Access Compliance Report

Public Rights-of-Way

(Curb Ramps)

Intersection ID: 50590	Main Street: GREEN_GRASS_RD	Cross Street: SITKA_CT	Location:	E
ADA ID: B14450A33BF6	Ramp Type: Perp	Initial Pass/Fail: Fail	Overall Compliance: No	Severity Score: 10
Codes/Mitigation Info/Possible Solution		Field Measurements/Component Compliance

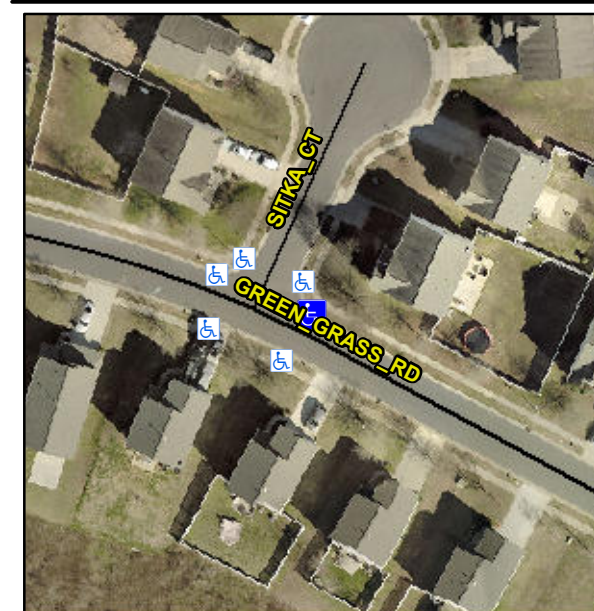
Not Found, R304.5.1, R304.5.3

Compliance	Description	Data	Compliance	Description	Data
N/A	Ramp Length (in)	47.5	Yes	Ramp Slope (%)	6.5
No	Ramp Width (in)	46.0	No	Ramp XSlope (%)	4.6
N/A	Flare Type LT	N/A	N/A	Flare Type RT	N/A
N/A	Flare Slope LT (%)	N/A	N/A	Flare Slope RT (%)	N/A
N/A	Flare Traversable LT?	N/A	N/A	Flare Traversable RT?	N/A
N/A	Landing Length (in)	N/A	N/A	DWS Provided?	N/A
N/A	Landing Width (in)	N/A	N/A	DWS Contrast?	N/A
N/A	Landing Slope (%)	N/A	N/A	DWS Length (in)	N/A
N/A	Landing X Slope (%)	N/A	N/A	DWS Full Width?	N/A
N/A	Landing Curb? (Y/N)	N/A	N/A	DWS Offset (in)	N/A
N/A	Shared Landing?	N/A			
N/A	Gutter Ponding?	N/A	N/A	Gutter Slope (%)	N/A
N/A	Gutter Lip Ht (in)	N/A	N/A	Gutter X Slope (%)	N/A
N/A	Painted X Walk1?	No	N/A	Painted X Walk2?	N/A
	X Walk 1 Direction	To SW		X Walk 2 Direction	N/A
N/A	X Walk 1 Width (in)	N/A	N/A	X Walk 2 Width (in)	N/A
	X Walk 1 Slope (%)	4.6		X Walk 2 Slope (%)	N/A
	X Walk 1 X Slope (%)	3.3		X Walk 2 X Slope (%)	N/A

Remove & Replace Entire Ramp.
